# Br. 196.6 Hydraulic Modeling (Bismarck, ND)

**REVIEW OF HYDRAULIC MODELING  
MISSOURI RIVER BNSF BRIDGE – BISMARCK / MANDAN, ND**

November 23, 2020

**Table 5-4**

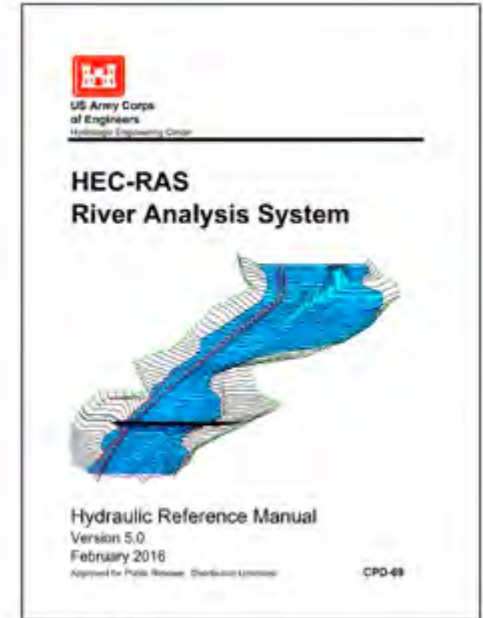
**R. Ackerman (AE):**  
Believes that Yarnell coefficient for existing structure may be too high and warrants discussion if 1D modeling is the only way through.

Because the BNSF Preferred Option has more blockage, the only way the Yarnell method will show "no rise" is to choose Yarnell coefficients where with the coefficient for the existing bridge is higher (less efficient) than the Preferred Option.

**R. Ackerman (AE):**  
Yarnell coefficient for existing structure should be between 0.90 and 1.05.

## Concept 3: 200ft Spans, Piers 42.5ft Upstream

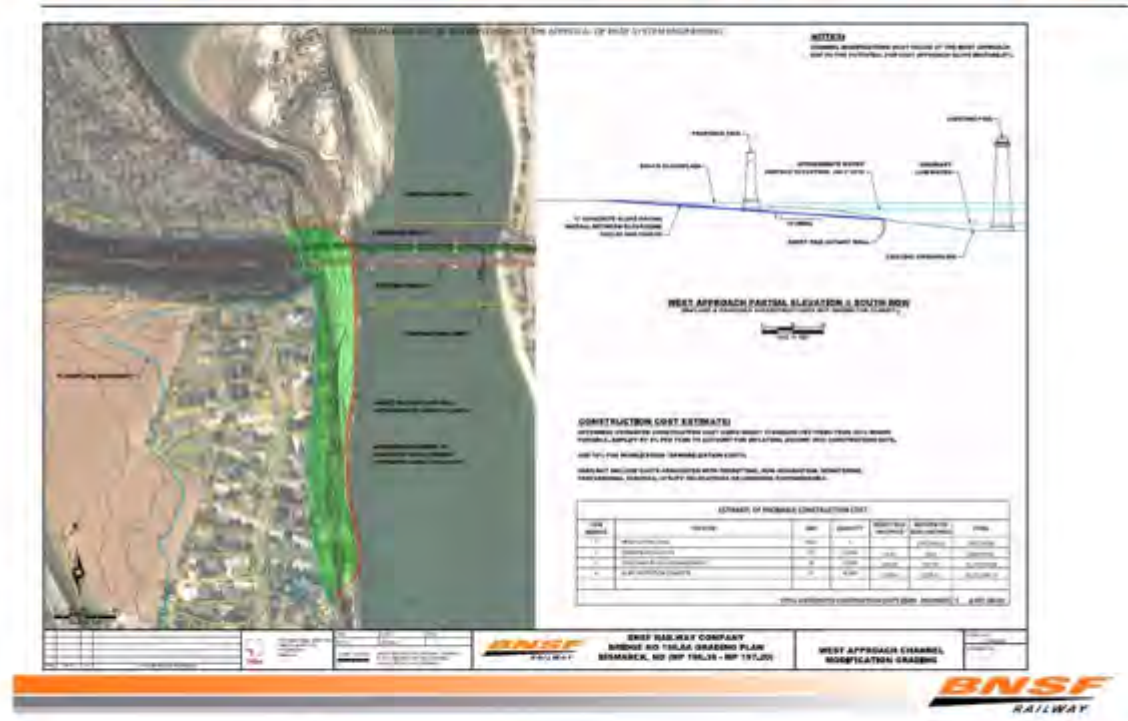
**R. Ackerman (AE):**  
1D modelling  
concurrs with BNSF  
conclusion of a rise  
for Concept 3.

# BNSF Concept 3 Impact Mitigation – Alternative Mitigation Concept

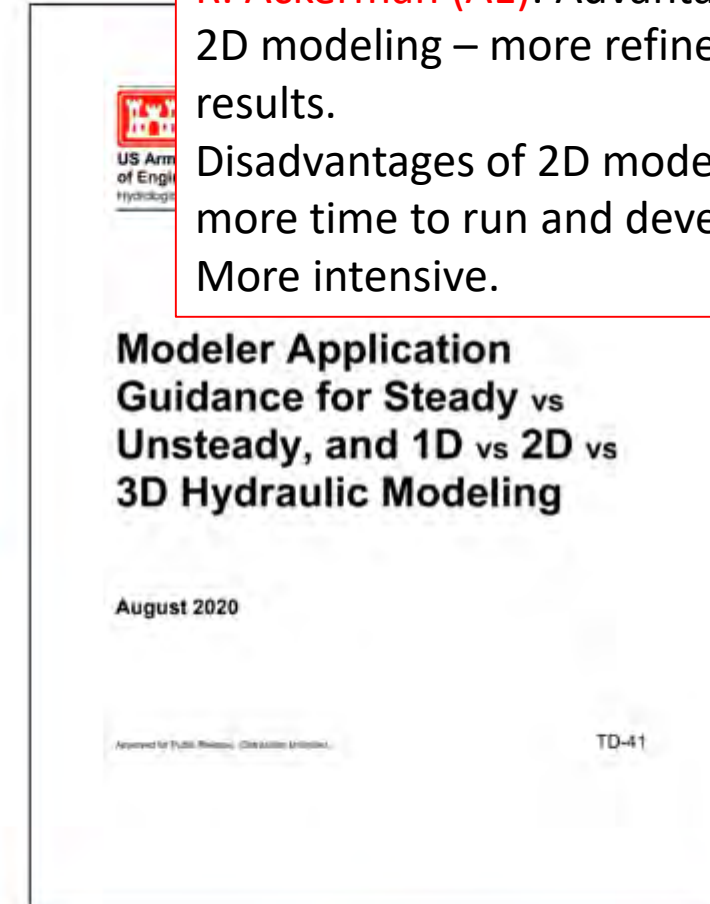
**R. Ackerman (AE):** Three 12-ft culverts would address 0.03 ft of rise.

**R. Ackerman (AE):** Is it appropriate to rely on results in 1D model. Is 2D more appropriate?

Considering the degree of precision of the inputs to the one-dimensional model (floodplain  $\frac{1}{2}$  to 1 mile across, cross sections hundreds to thousands of feet apart, etc.) is it appropriate to definitively rely on the output results to a precision of 0.001 foot? Is there a more appropriate analysis method?

## Alternative Hydraulic Modeling Approach (2-Dimensional Modeling)

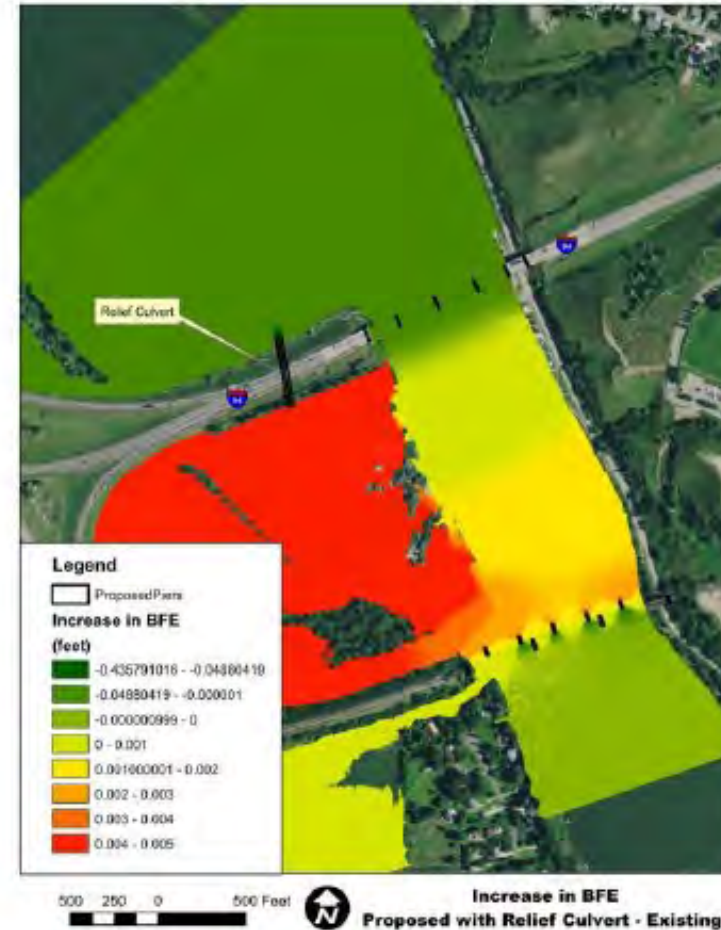
- ❖ Relief culverts allow flow on the west floodplain and mitigates rise upstream of Interstate 94

**R. Ackerman (AE):** Could mitigate rise shown in 2D modeling with one 12-ft relief culvert.
